National Committee on Uniform Traffic Control Devices (NCUTCD) Recommended Changes to Proposed Text for 11th Edition of the MUTCD Docket Number: FHWA-2020-0001

15 16 Federal Register Item Number: 292 - 294 **NPA MUTCD Section Number: 2K**

The following pages present the GMI Technical Committee recommendations for changes to the MUTCD NPA proposed text and figures for Chapter 2K. Below is a summary of the GMI Technical Committee positions on Chapter 2K.

Figure 2K-1. Examples of Tourist-Oriented Directional Signs

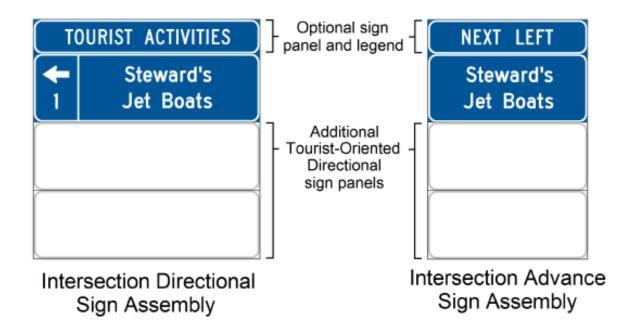
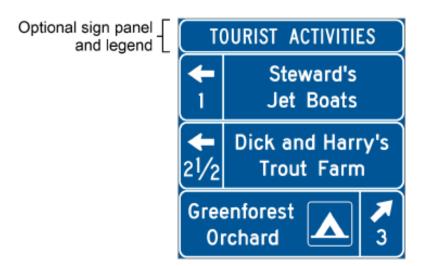
NCUTCD agrees with Figure 2K-1 as presented in the NPA.
